Service Bulletin No. 308

| SUBJECT ZF SOFTWARE UPDATE CAMPAIGN FOR CELL PHONE & RADIO INTERFERENCE | | | |

No. 08_19

Software Update campaign because of cell phone and radio interference (NHTSA no.06E100)

Figure 1. NO cellular phone decal.

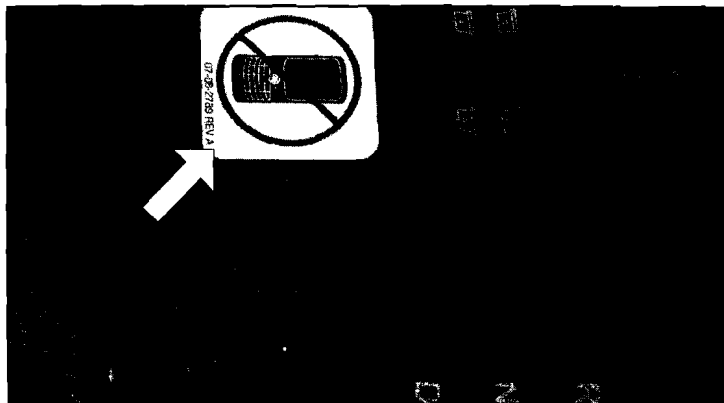
Installation of a warning sticker onto the dashboard area

- to avoid any malfunction due to the use of electronic equipment (ZF part no.: 1348 753 101)

The only part required for this change is the 07-08-2789 Decal.
